Subject: Exelon Nuclear Texas Holdings, LLC
Victoria County Station Early Site Permit Application
Response to Request for Additional Information Letter No. 18
NRC Docket No. 52-042

02.05.02-11

RAI 02.05.02-11:

Figure 1a Houston demonstration site 10 Hz hard rock hazard curves: comparisons of several source models.

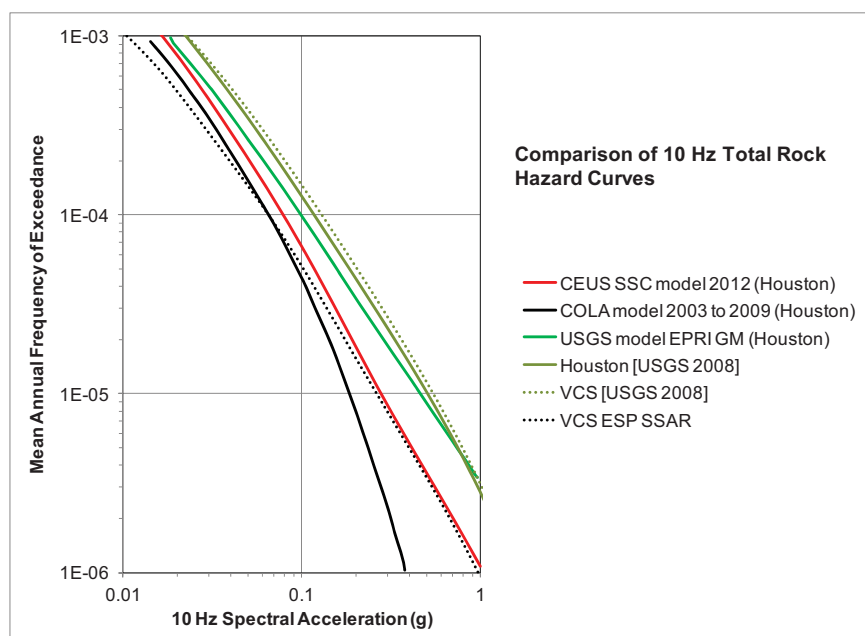
This request for additional information (RAI) specifically addresses Recommendation 2.1 of the Fukushima Near-Term Task Force recommendations contained in SECY-12-0025, as it pertains to the seismic hazard evaluation. This Recommendation specifies the use of NUREG-2115, "Central and Eastern United States Seismic Source Characterization for Nuclear Facilities" (CEUS-SSC), in a site probabilistic seismic hazard analysis (PSHA). The NRC staff issued NUREG-2115 in January 2012, marking the completion of approximately four years of collaborative work between NRC, the Department of Energy, and the Electric Power Research Institute.

- a) Evaluate the potential impacts of the newly released CEUS-SSC model, with potential local and regional refinements as identified in the CEUS-SSC model, on the seismic hazard curves and the site-specific ground motion response spectra (GMRS). For re-calculation of the PSHA, please follow either the cumulative absolute velocity (CAV) filter or minimum magnitude specifications outlined in Attachment 1 to Seismic Enclosure 1 of the March 12, 2012 letter "Request for information pursuant to title 10 of the *Code of Federal Regulations* 50.54(f) regarding recommendations 2.1, 2.3, and 9.3, of the near-term task force review of insights from the Fukushima Dai-ichi accident." (Agencywide Documents Access and Management System Accession No. ML12053A340).
- b) Modify the site-specific GMRS if you determine changes are necessary given the evaluation performed in part a) above.

The three panels of Figure 1 show comparisons of mean hard rock hazard curves from several source models for 10 Hz, 1 Hz, and PGA response spectral accelerations. The heavy solid lines (from Figures 8.2-3j, 8.2-3k, and 8.2-3l of NRC, 2012a) compare hazard at the Houston, Texas, demonstration site for the current CEUS SSC source model (heavy red line), the USGS model developed for the National Seismic Hazard Mapping Project (Petersen et al., 2008) (heavy bright green line), and a “COLA” model (heavy black line) that has been used for nuclear power plant licensing applications between 2003 and 2009. According to the CEUS SSC report, the “COLA” model is the EPRI-SOG (EPRI, 1988) model updated with more recent characterizations for the New Madrid fault source, the updated Charleston seismic zone, and an update of maximum magnitude values for some seismic sources near the Gulf of Mexico to reflect recent seismicity. Additional details of this “COLA” model are not available in the CEUS SSC report (NRC, 2012a). Calculations of hazard for all three of these models use the EPRI (2004, 2006) ground motion prediction equations (GMPEs) so that the differences in hazard presented among the three models are attributable to differences in the source models themselves.

Also shown in each of these three panels are three additional mean hazard curves that have been included as part of this RAI response. The two olive green lines are hazard curves for the Houston (solid) and the VCS (dotted) sites from the USGS source model and USGS GMPEs. The difference, then, between the solid olive green and solid bright green hazard curves should arise from GMPE differences [EPRI (2004, 2006) vs. Petersen et al. (2008)]. The difference between the two olive green lines [solid and dotted] arises from their different locations within the USGS model.

The third additional line (dotted black line) in each panel is the hard rock VCS ESP SSAR hazard curve for that frequency. Since both the black dotted and heavy black solid hazard curves use the EPRI (2004, 2006) GMPEs and both use updated versions of the EPRI-SOG model these two lines might be expected to match each other closely. This is the case, in fact, only for the 1 Hz hazard curves. The reasons for the differences for the hazard curves at higher frequencies are unknown – and pertinent additional details of the “COLA” model are not available in the CEUS SSC report (NRC, 2012a) – but could be caused by details of the geographic distribution of local seismic activity rates and/or difference in lower bound magnitudes used in the two analyses.
